Staff Report

File #: 24-183

City Council review of an appeal filed by a neighboring property owner following the Planning Administrator's decision approving a 405-unit multi-family residential development, Urban Growth Area Preliminary Declaration, Class 3 Site Plan Review, Class 1 and Class 2 Adjustments, Class 2 Driveway Approach Permit, Class 1 Design Review, and Property Line Adjustment Case No. UGA-SPR-ADJ-DAP-DR-PLA24-03 for property located at 4650 Hazelgreen Road NE.

**URBAN GROWTH PRELIMINARY DECLARATION / CLASS 3 SITE PLAN
REVIEW / CLASS 2 ADJUSTMENT / CLASS 1 ADJUSTMENT / CLASS 2
DRIVEWAY APPROACH PERMIT / CLASS 1 DESIGN REVIEW / PROPERTY
LINE ADJUSTMENT CASE NO.: UGA-SPR-ADJ-DAP-DR-PLA24-03**

PRELIMINARY LANDSCAPE PLAN - NORTH
NORTHPLACE APARTMENTS PHASE 2
I&E CONSTRUCTION, INC.
SALEM, OREGON

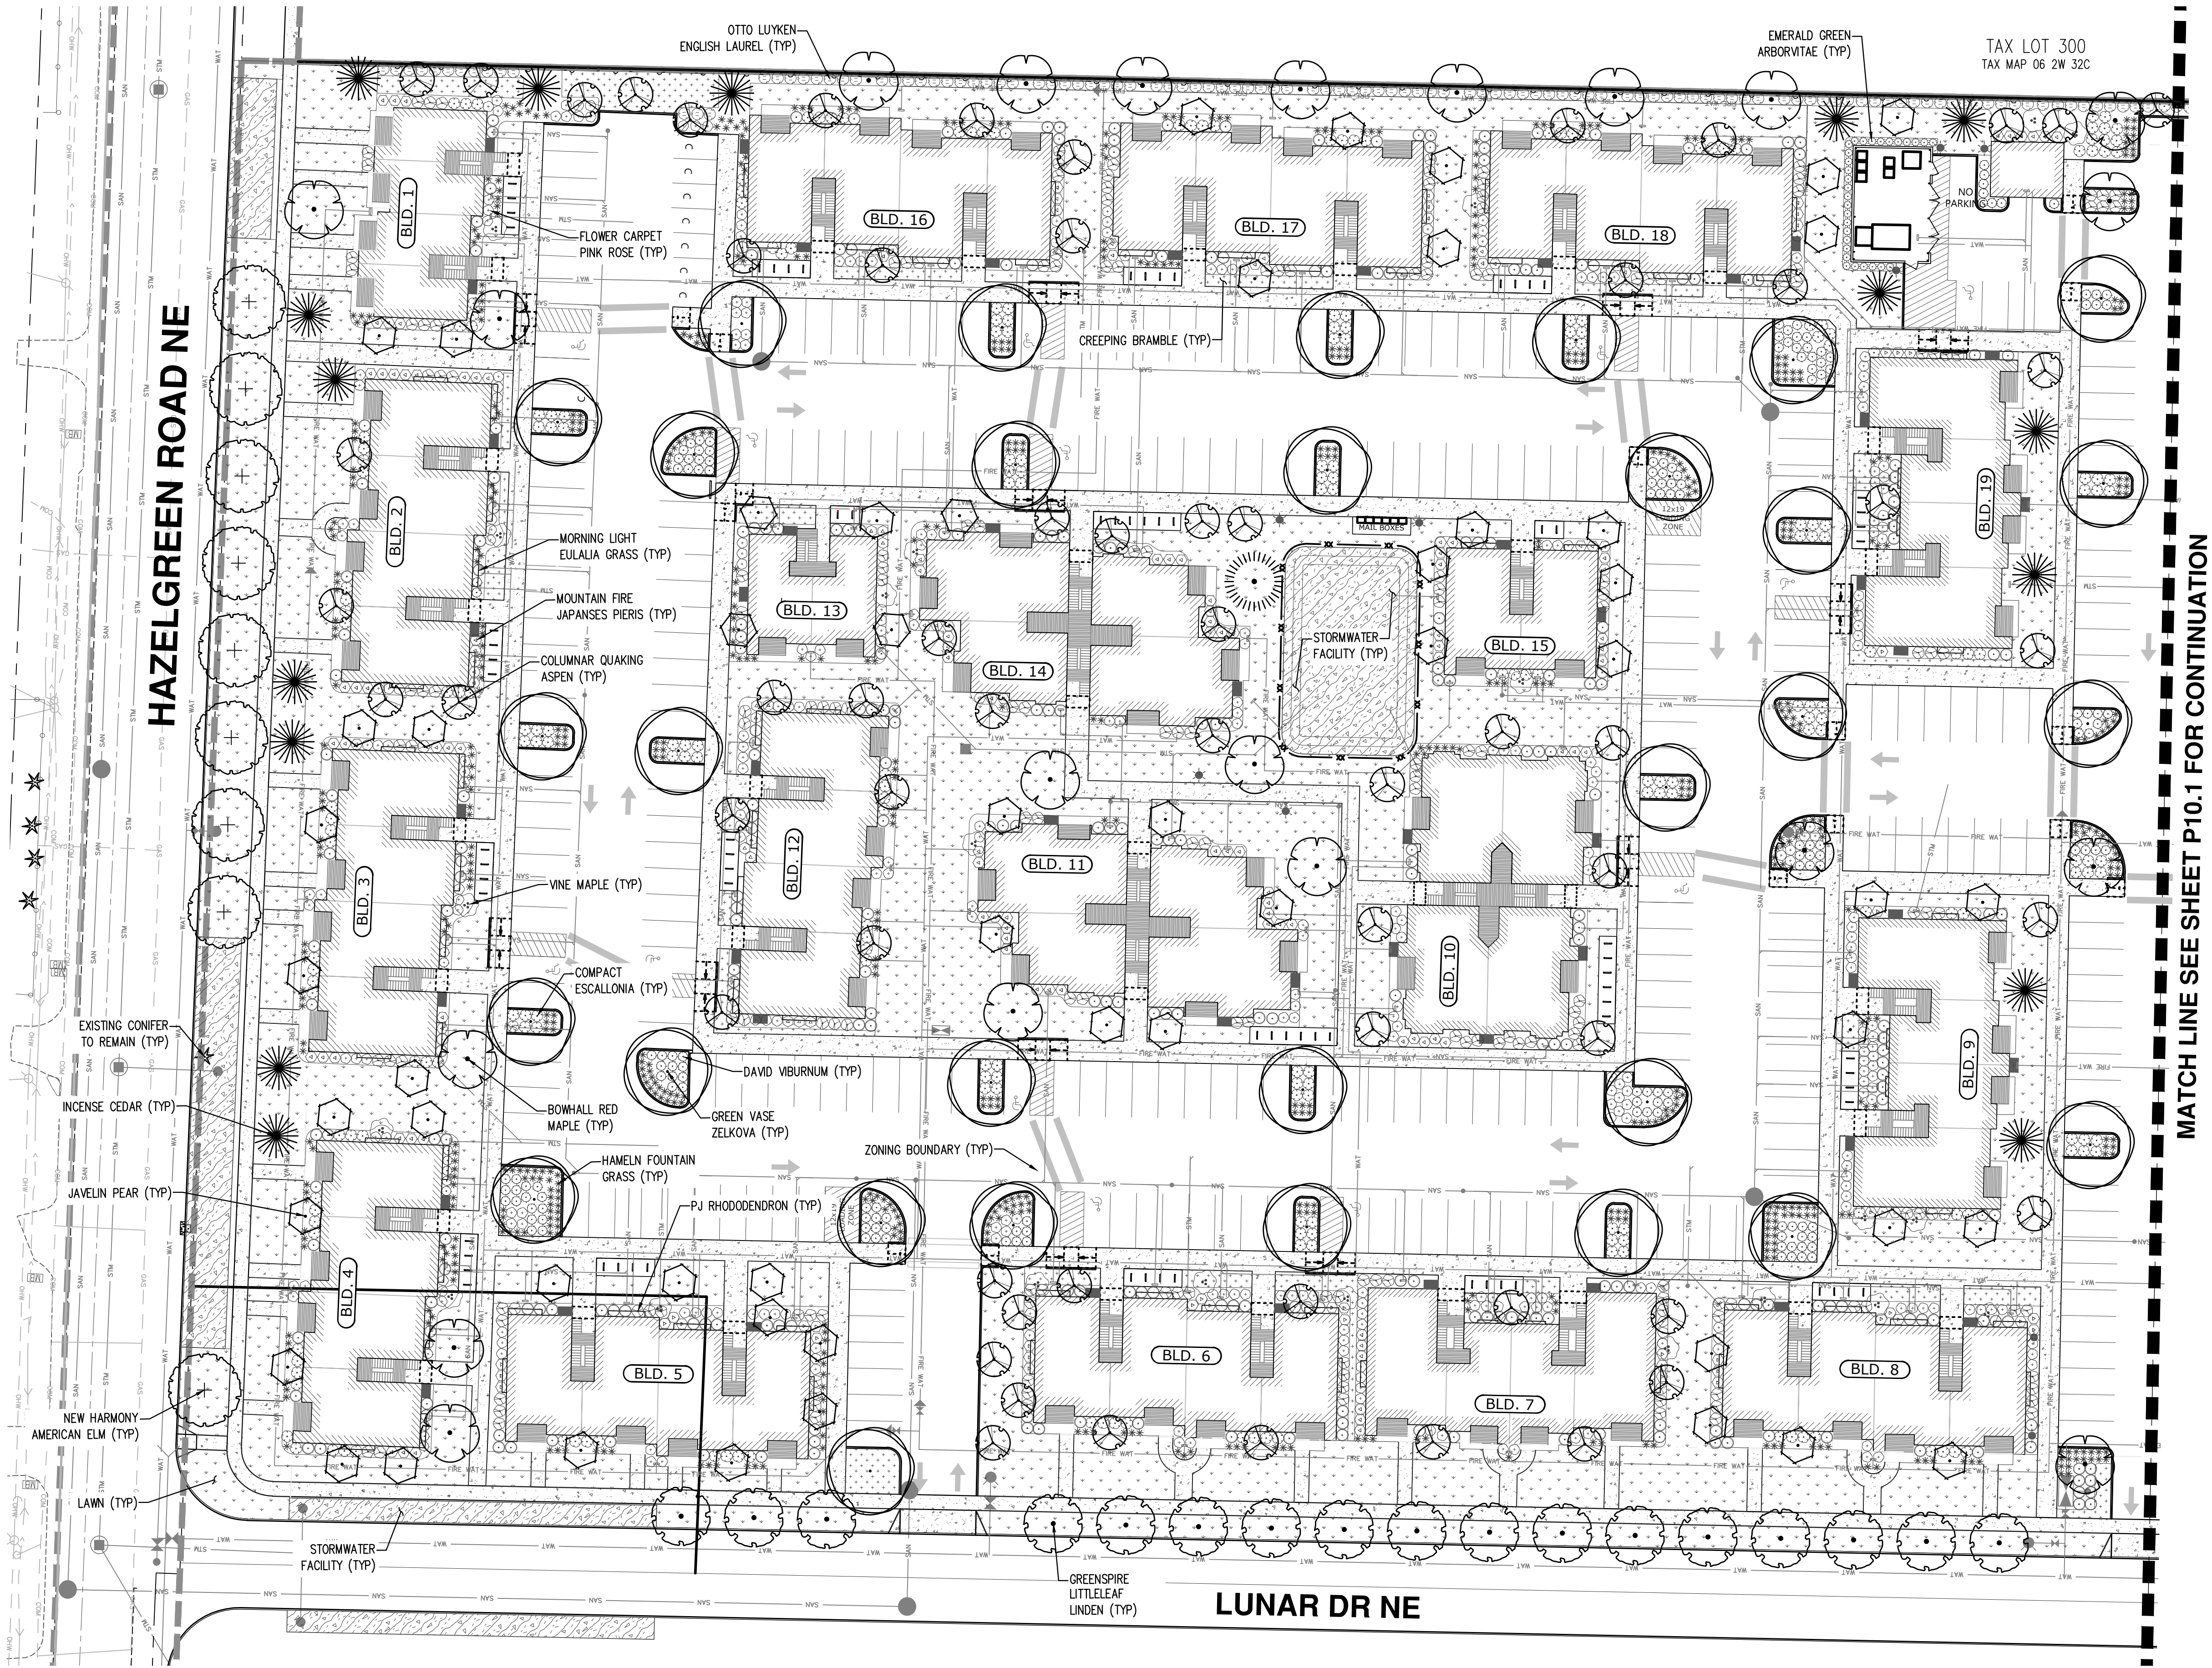
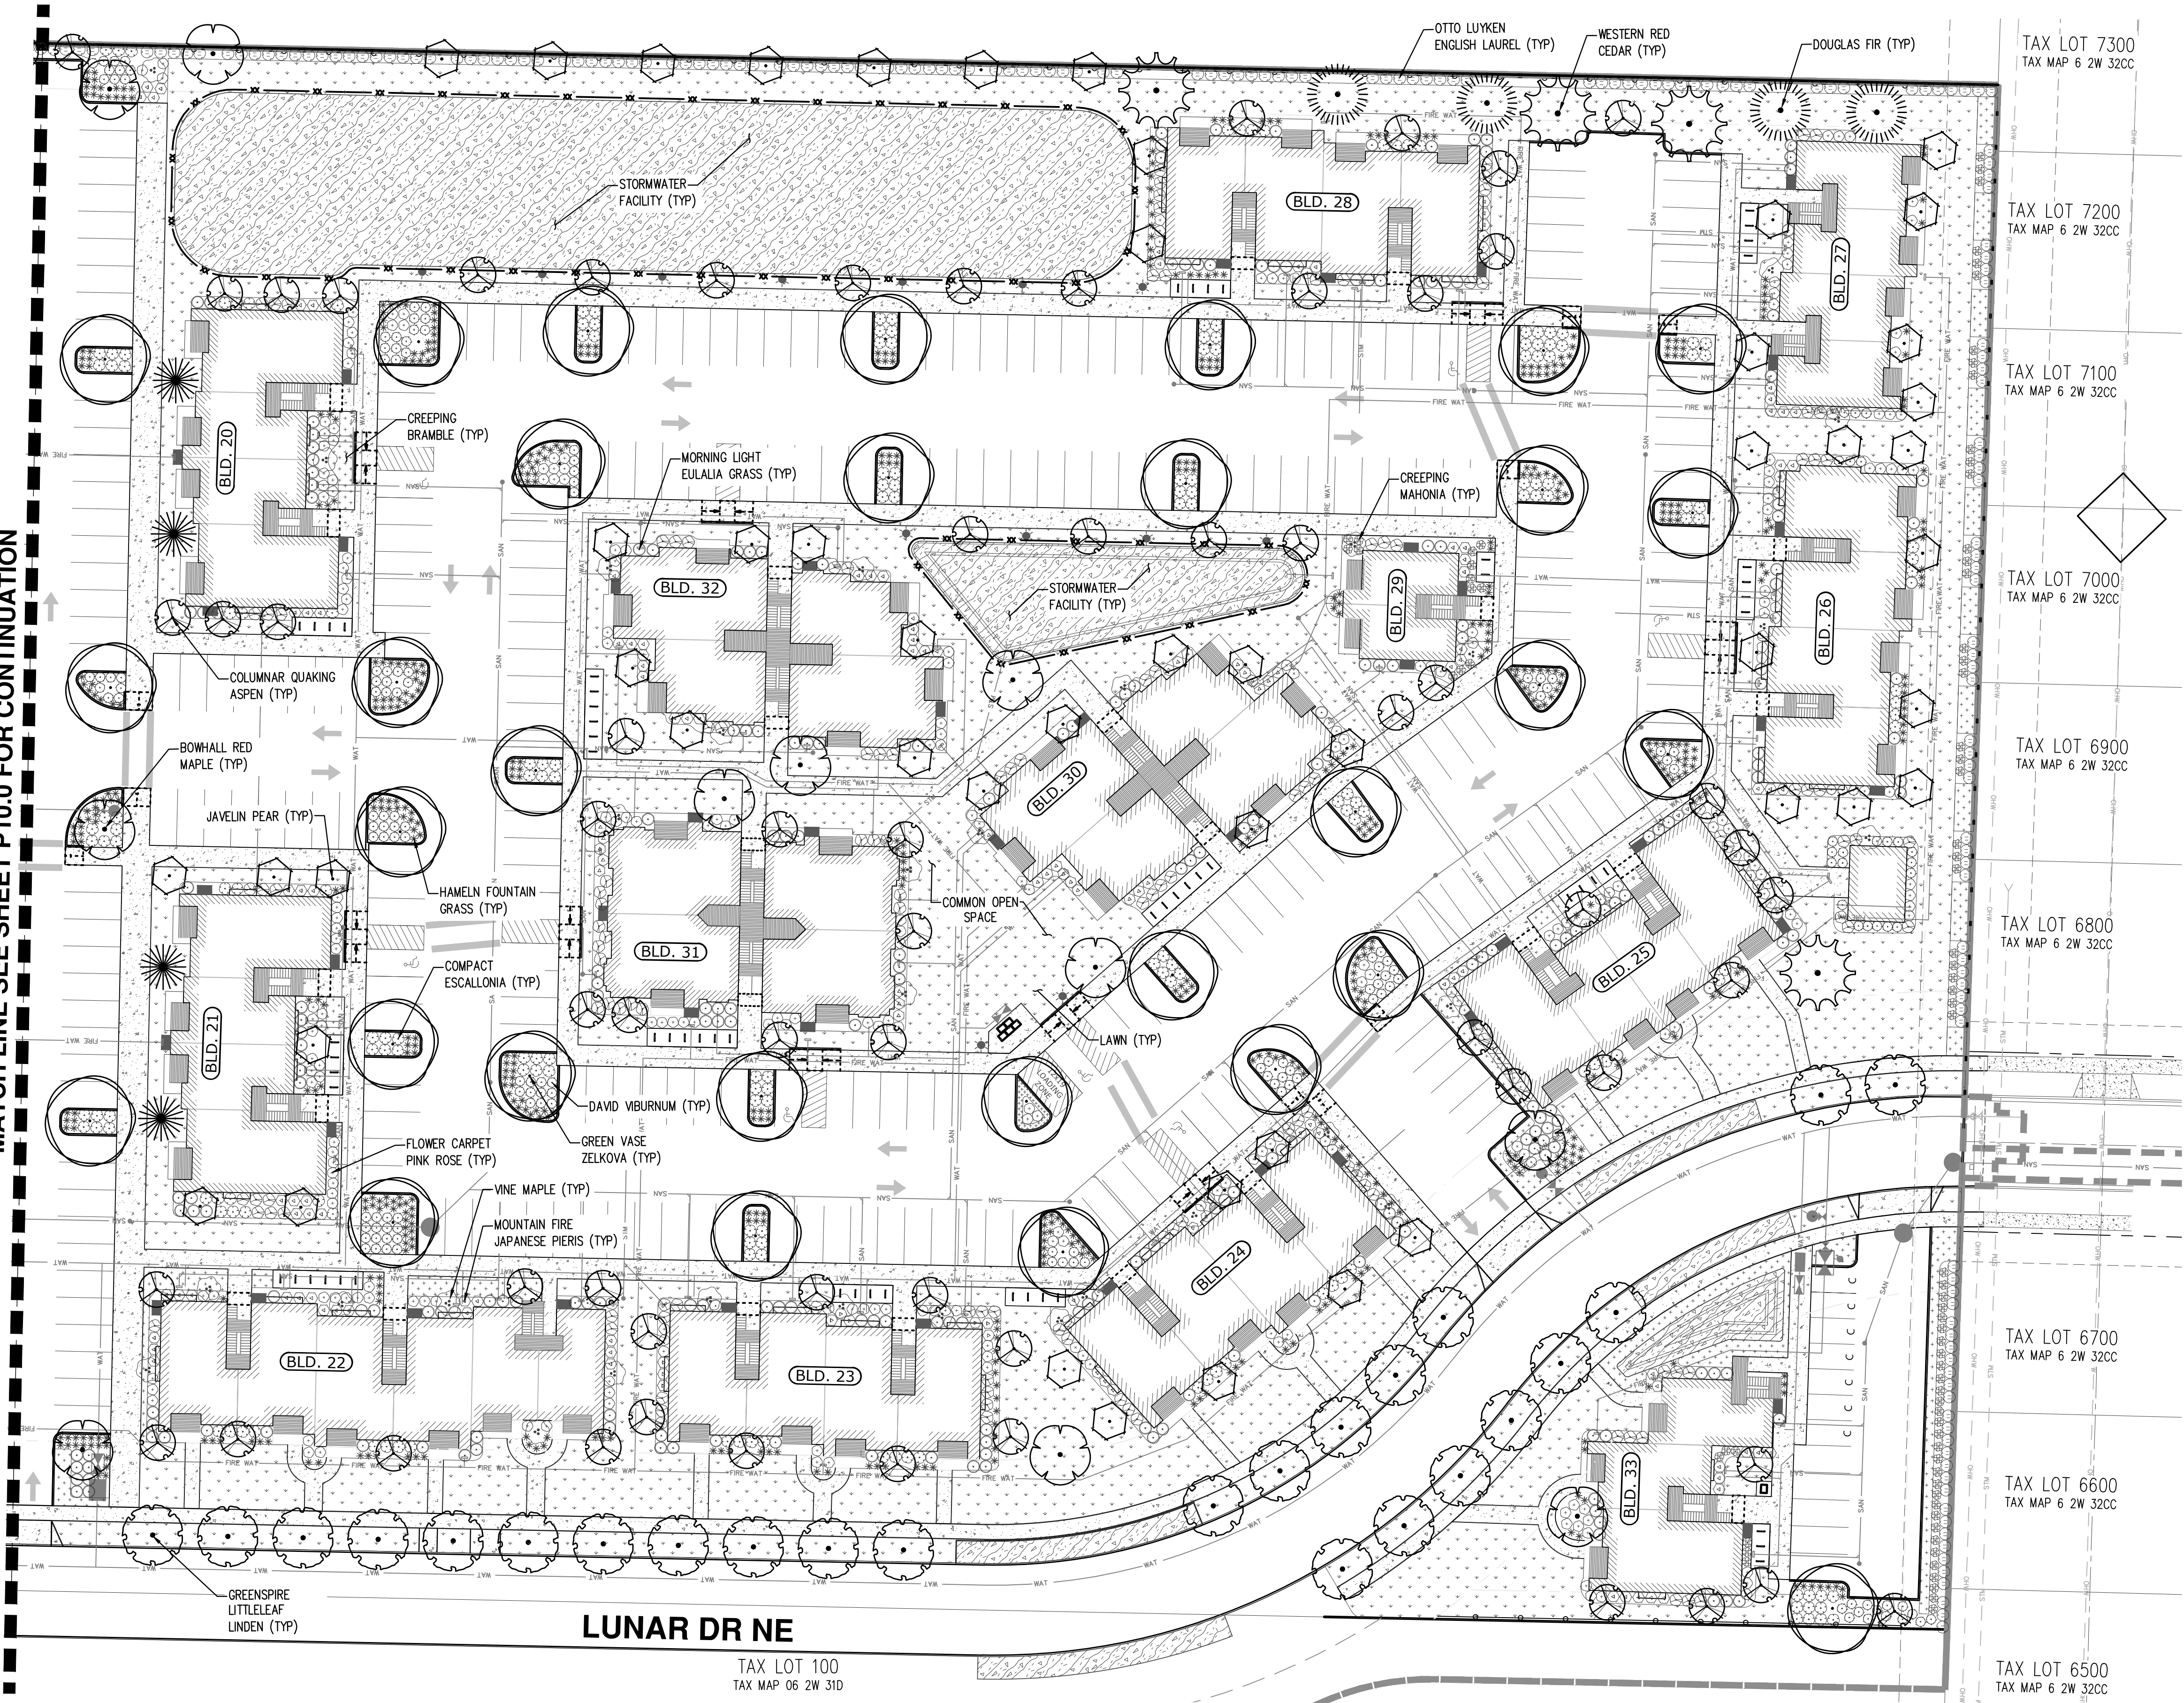
- The appellant indicates that the applicant's proposal to plant two species of shrubs along the southern boundary to provide a physical and visual barrier does not equally or better meet the intent of SRC 702.020(b)(2), which states that a combination of screening and landscaping shall be used to create a buffer.

A dwarf form of the larger English Laurel, Otto Luyken English (or Cherry) Laurel is an evergreen shrub that typically grows 3 feet tall and spreads 6 to 8 feet. The plant's fruit, leaves, and stems are poisonous to humans. As shown on the preliminary site plan (P10.1), this species will be planted along the southernmost boundary for the Subject Property. Just behind these, the applicant intends to plant Creeping Mahonia (also known as Creeping Oregon Grape), which is an extremely short, sprawling shrub that commonly grows no more than 8 to 12 inches and occasionally up to 2 feet. Suffice it to say, these two plant species, even when fully mature, cannot and will not provide an equal measure of privacy, nor visual character, nor buffer between the Subject Property and Appellant's property than trees (one tree for every 30 linear feet of abutting property width) and the 6-foot decorative fence or wall that is required by SRC 702.020(b)(2). Therefore, the proposed development does not *equally* meet the underlying purposes of this specific development standard.

Staff Response: The applicant's landscape proposes to landscape the southern boundary with shrubs that at maturity will provide a dense physical and visual barrier and be consistent with the height limitations for vegetation within the BPA easement. The applicant explored providing denser group of plantings within the easement at the time of installation, however, landscape needs time to grow and adequate space thrive. Landscaping that is planted that too dense may not grow as intended, therefore this option was not selected. Due to the restrictions of the BPA easement, the unique distance the easement creates between uses, and a landscape plan which will provide a dense group of shrubs that will provide a physical and visual barrier at maturity, staff found the requested Adjustment to be consistent with the approval criteria.
